UPDATE CHANGE NOTIFICATION # 16746Generic Copy

TITLE: Deleted the Sleeve (Tube) device name from the PB16746 which change packing standard by removing protective band from plastic reel at ON Semiconductor (Thailand).

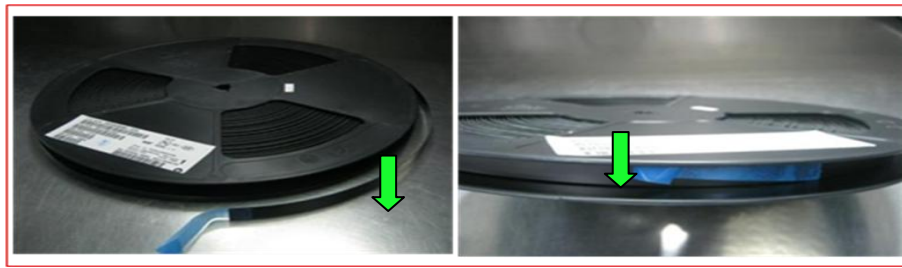
Before Change: The protective band covers the reel then closes the end by Blue ESD tape.

After Change: Blue ESD tape closes the end of the reel packing.

Before Change: Carrier tape + protective band + ESD tape (short length around 5 cm.)

After Change: Carrier tape + ESD tape (increase length to 20 cm for small package and 30 cm for SOIC and TSSOP, this will prevent the reel to easily peel off)
